Amendments to the Drawings:

Attached are two sheets of replacement drawings, which include changes to Figs. 1, 2, 3, 8 and 9. These attached sheets replace the two original sheets of drawings filed with the present application. Figs. 1, 2 and 3 have been amended to substitute the label "Prior Art" for the original label "art antérieur." In Figs. 8 and 9, the previously omitted reference numeral 24 has been added.

REMARKS**I. Status Of The Claims**

Fig. 1

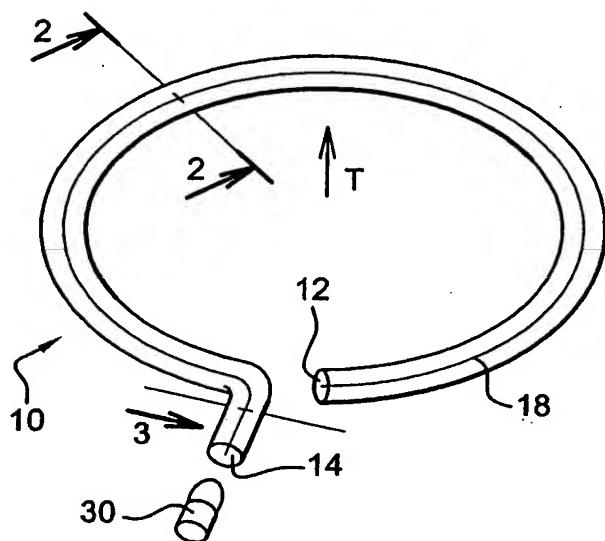
In the October 18, 2005 Office Action, the Examiner noted that Figures 1-3 of the present application are labeled “art antérieur” instead of “Prior Art.” The Examiner objected to the Figures because each of the reference numerals “26” and “34” are recited in the specification with regard to two different features of the present invention. The Examiner also objected to Figures 8 and 9 because they do not include reference numeral “24” as described on pages 14 and 15 of the specification.

"Prior Art" substituted
for "art antérieur"

In response to the Examiner’s comments and objections, Applicants submit herewith a set of corrected drawing sheets. Figures 1-3 have been amended to substitute the label “Prior Art” for the original label “art antérieur.” In addition, Figures 8 and 9 have been amended to include reference numeral 24 to identify the “rear peripheral portion 24” as described in the specification at pages 14 and 15.

Fig. 3

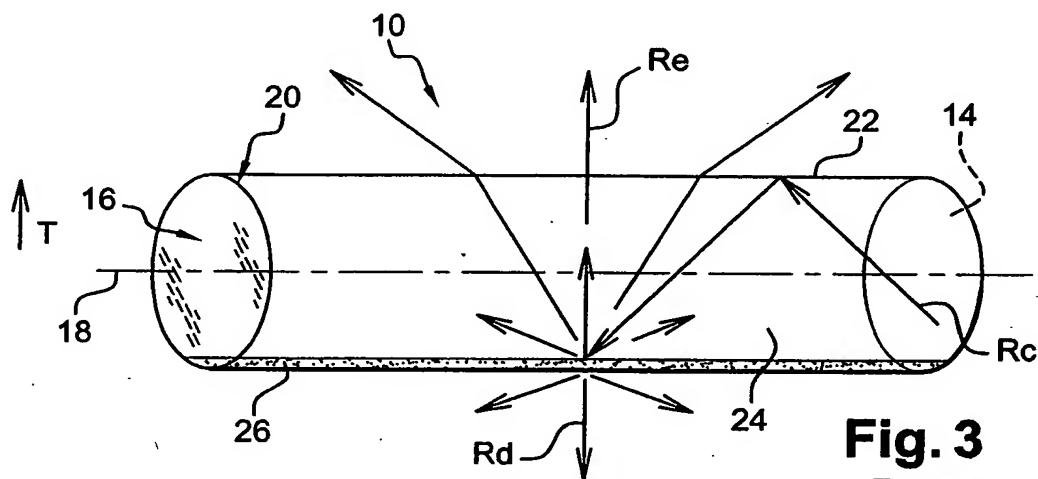
"Prior Art" substituted
for "art antérieur"
